US-APWR NRC Questions

April 18, 2008 Mitsubishi Heavy Industries, Ltd.

4GG-UAP-20080026-0

Typical Timing Chart Of Operation

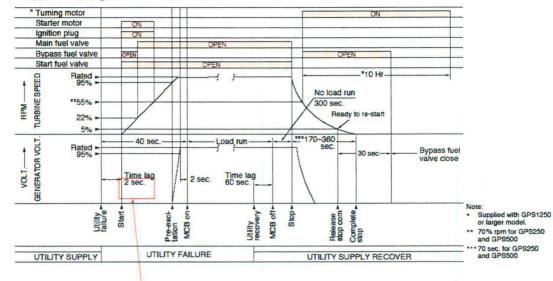
NRC Question – Governor and Excitation of GTG (1/6)

Discuss the excitation and governor systems of the gas turbine

TYPICAL OPERATION, TIMING CHART

The required time to confirm the black out.
